AMBASSADOR HOTEL - APARTMENT CONVERSION PLANNED DEVELOPMENT (PD)

SUMMARY

Applicant's Request: Planned Development (PD) approval to convert the existing Ambassador Hotel into the 150-room Palm Gardens Low Income Apartments, with a bonus to allow up to 55 dwelling units per acre. The property is zoned MU-1/T & O-1/T. A concurrent Future Land Use Map amendment is being requested to change the northern 0.69-acre portion

Updated:
June 15, 2022

PROPOSED LANDSCAPE PLAN

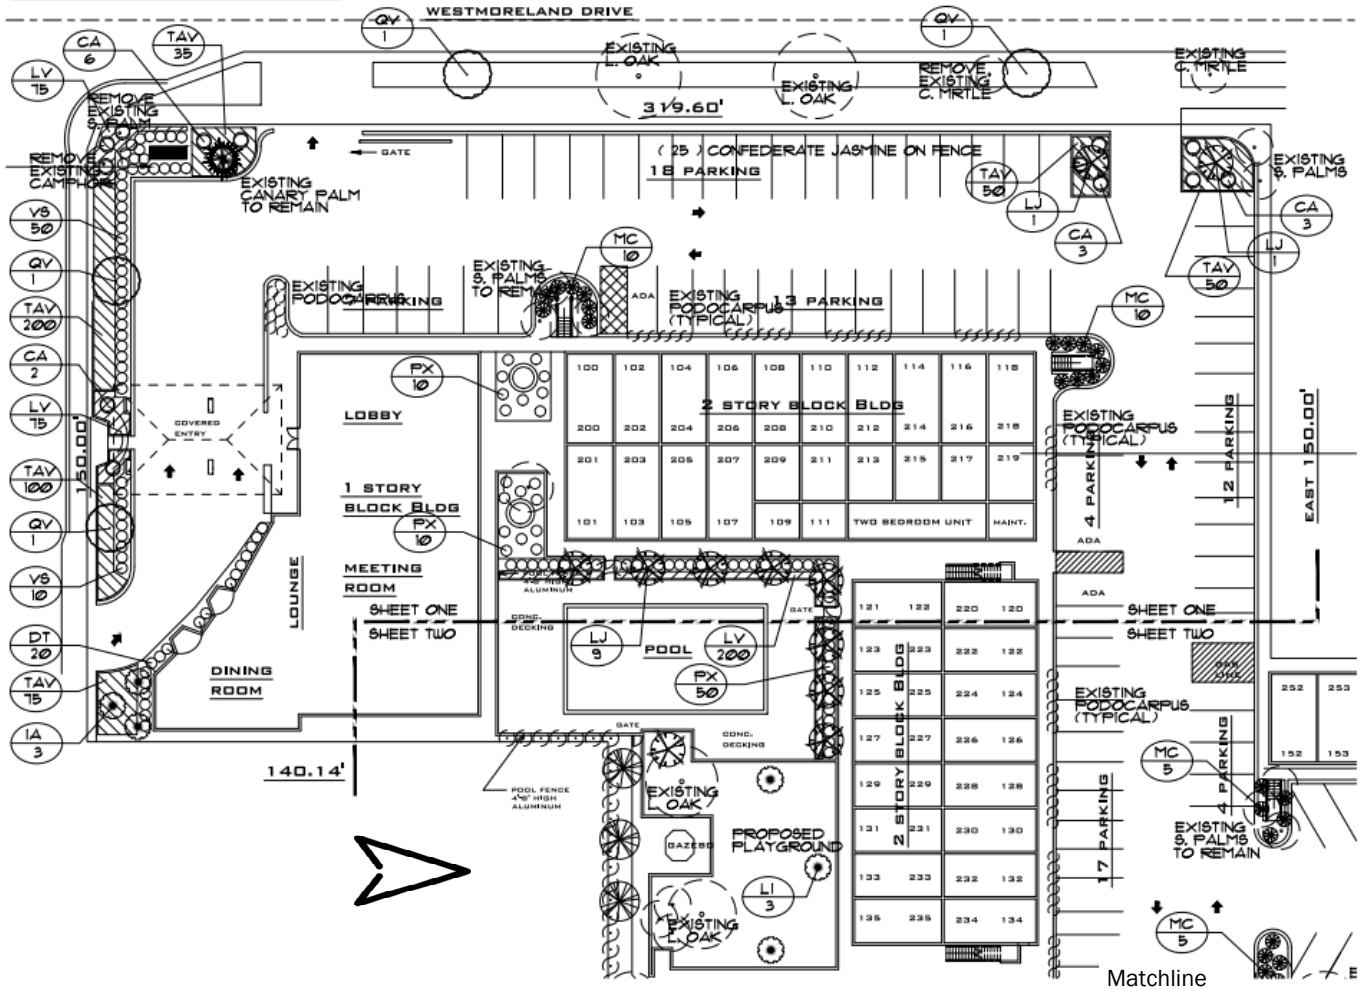
8. Additional information is needed on sheet L-0001 regarding bufferyards (pursuant to LDC Chapter 60, Part 2, Section 2E) and street tree installation (pursuant to LDC Chapter 60, Part 2, Section 2D) for the frontages along W. Colonial and N. Westmoreland Drives.

11. The proposed minimum height and width information for all tree specifications must be provided on the landscape plan. The plans list MT under most plant specifications, but clarify the minimum height of the plant.

16. Additional information is needed on sheet L-0001 indicating where tree protection fences will be installed surrounding existing/preserved trees.
17. Additional information is needed on sheet L-0002 to ensure that dumpsters are enclosed within a solid masonry wall finished to match the building, with solid decorative gates provided to screen the openings when not in use.

18. Additional information is needed on sheet L-0002 to identify if the Gazebo is existing or proposed. If it is proposed, please provide elevations and dimensions of the proposed structure.

19. Additional information is also needed on sheet L-0002 regarding the proposed playground surface material and fall attenuation details.
